**EAST GOSHEN TOWNSHIP
PLANNING COMMISSION
Meeting Agenda
Wednesday, February 1, 2017
7:00 PM**

SUBDIVISION AND LAND DEVELOPMENT PLAN
(PRELIMINARY/FINAL) FOR
BRAKMAN PROPERTY

SANITARY SEWER PROFILE AND DETAILS

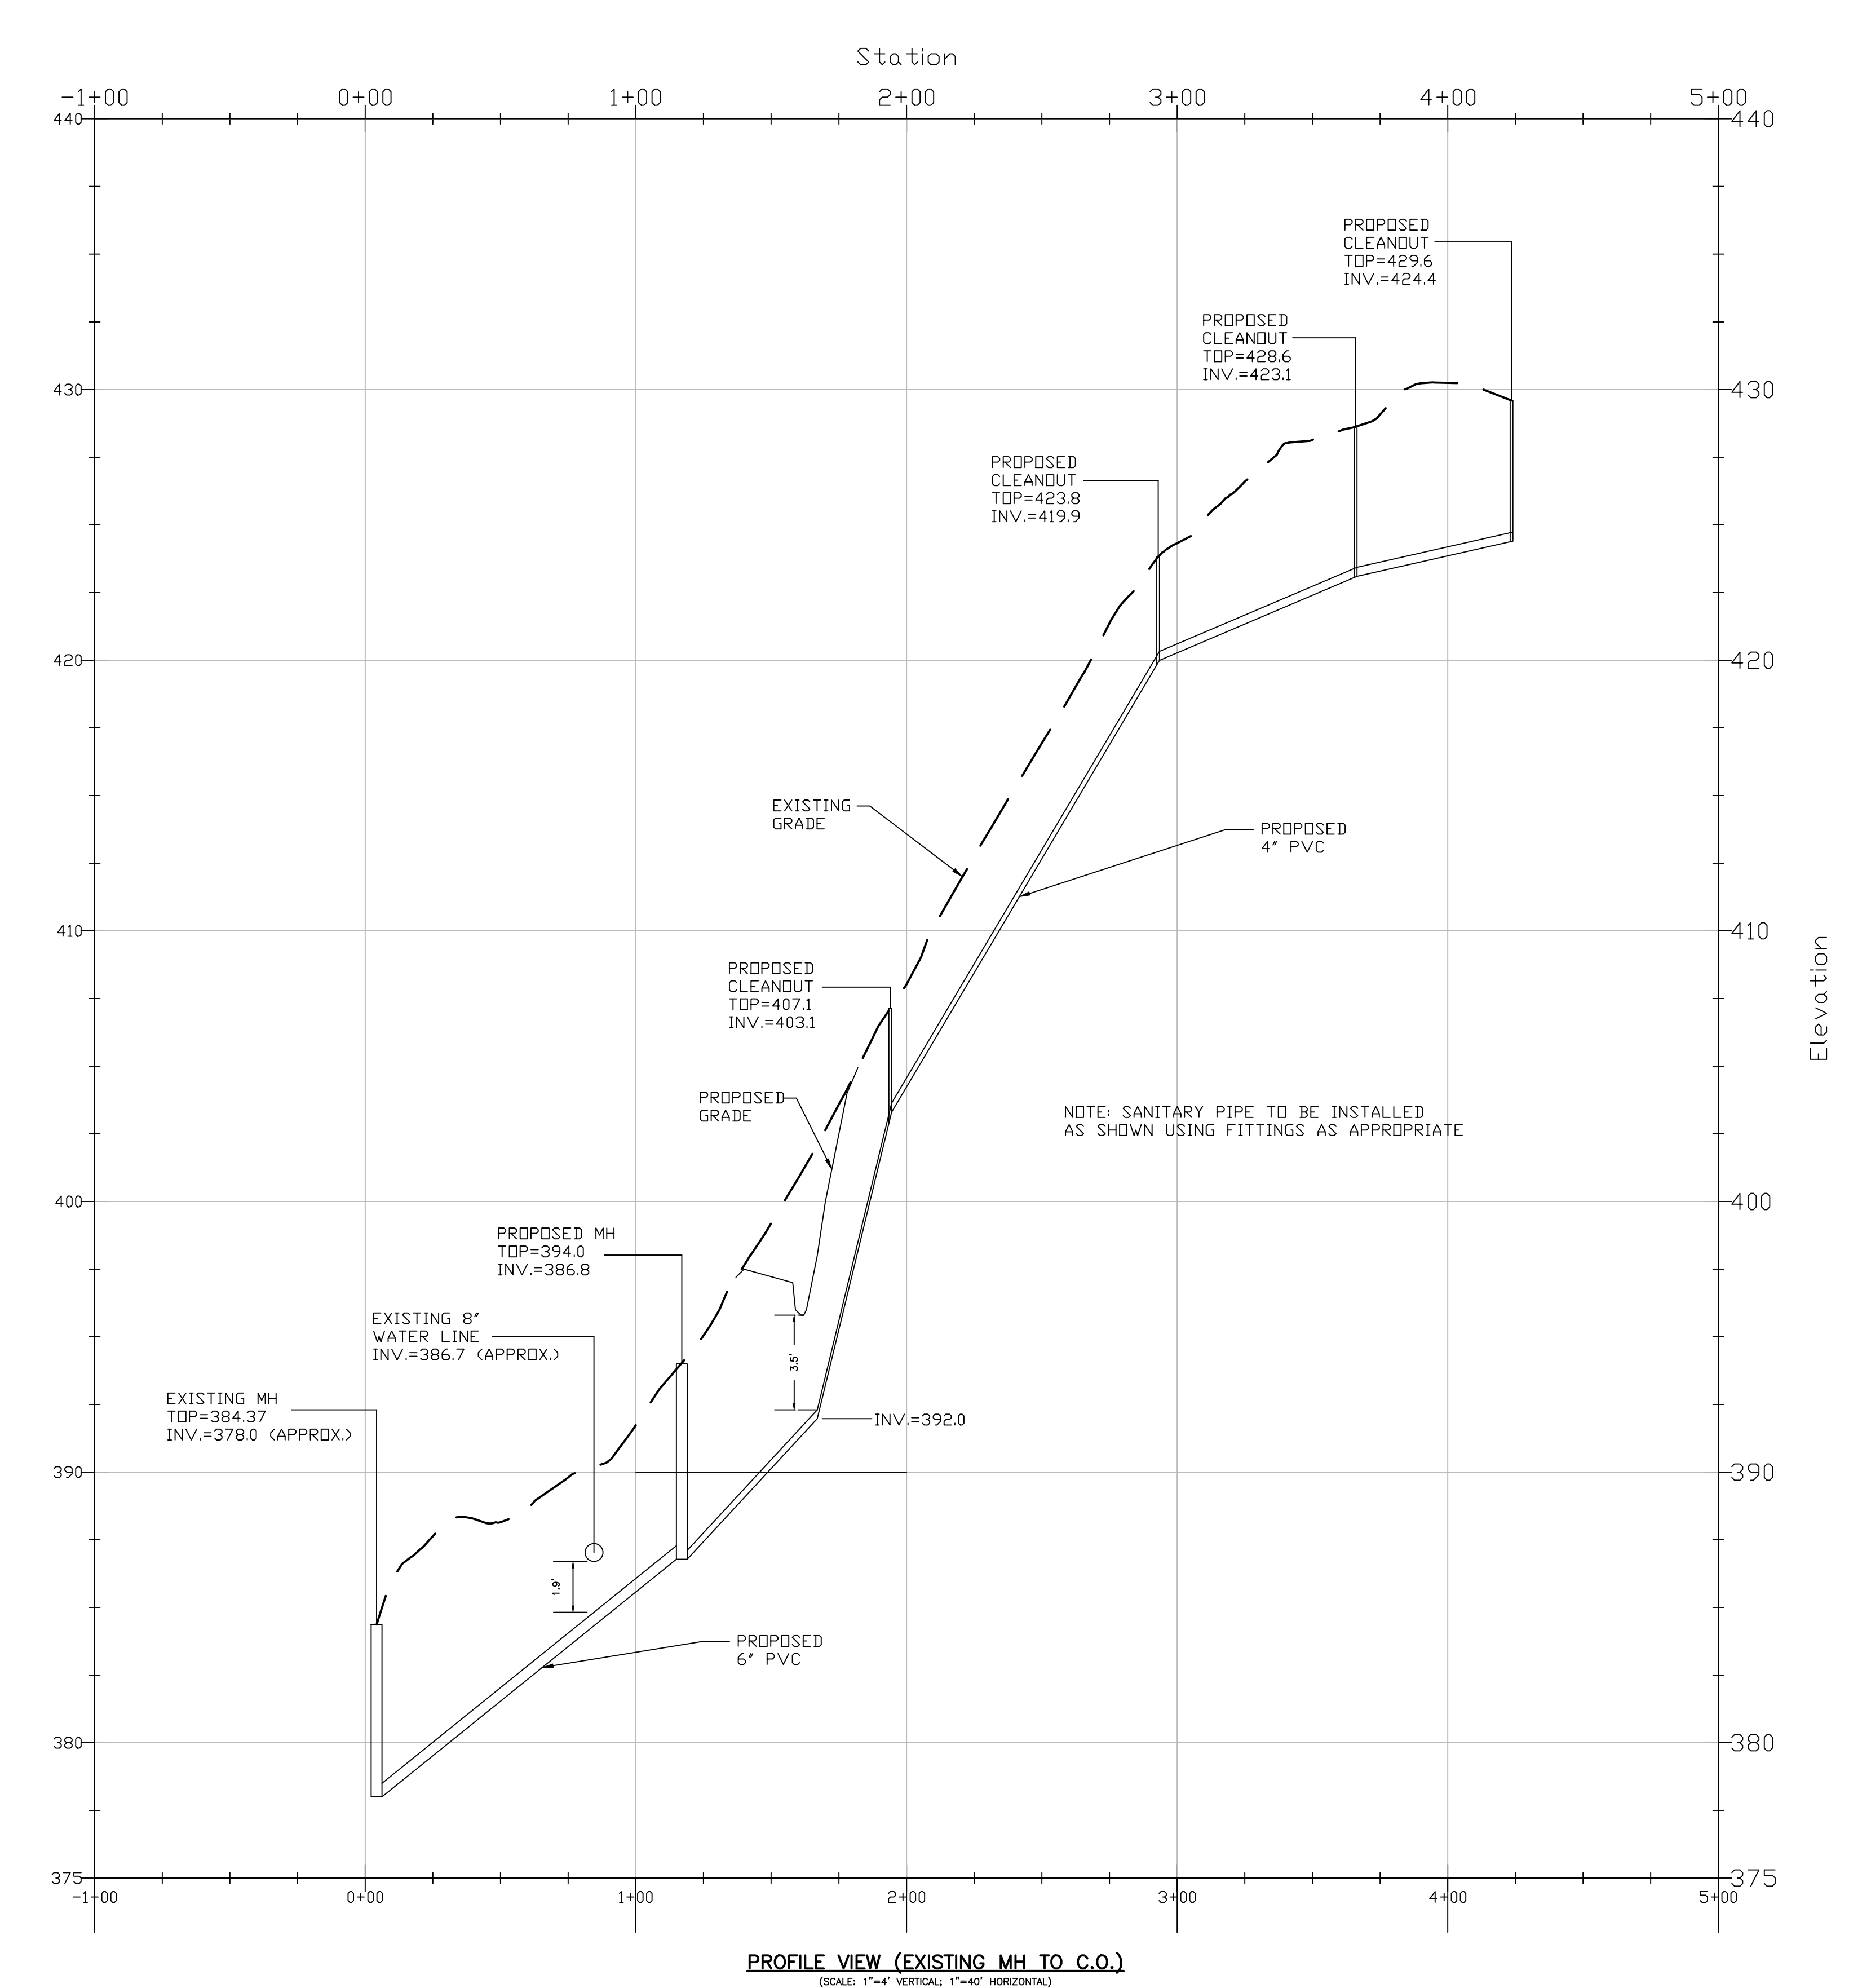
An additional manhole has been proposed on the subject property with Standard Manhole Detail Note #14 on Sheet 10 stating that any manhole receiving force main discharge should be lined with a PVC liner. For clarity, this note should call out the referenced manhole specifically and state that it shall receive a Duraplate-type PVC liner or approved equal.

Installation Note #3 has been added on Sheet 10 that all gravity sewer pipes should be installed as per §188-31.C. This note should also reference the "East Goshen Township Sewer Lateral/Building Sewer Detail" if not including the detail on this plans. We recommend that the detail be added to the plans to ensure compliance.

- j. The profile view (Sheet 10) indicates that the existing water main has less than 3 feet of cover. We understand this is the depth at which Aqua believes the main MAY be located. The Applicant should consider installing the sewer main a little deeper at this location to minimize the risk of a conflict, specifically since the new manhole may not be deep enough to address such a conflict.

9. The following comments are in regards to the new Standard Manhole detail and notes on Sheet 10:
 - a. The manhole cover adjustment note should only reference precast grade rings; the reference to bricks should be deleted.

16. A note labeled as "Installation Note" has added to Sheet 10.
17. A utility easement on the Kaplan property is required as indicated on the plans.
17. The utility easement has been revised accordingly per the revised sanitary sewer design.

19. The above information has been included as part of the note labeled as "Installation Note" on Sheet 10.
20. We recommend the inclusion of additional details or notes regarding the gravity sewer lateral from the house to the grinder pump including, at minimum, pipe material, size, cleanout, trap, and vent cap.
20. Details and notes (under "Installation Notes") have been added to Sheet 10. Also, cleanouts have been added to all gravity sewers as appropriate.
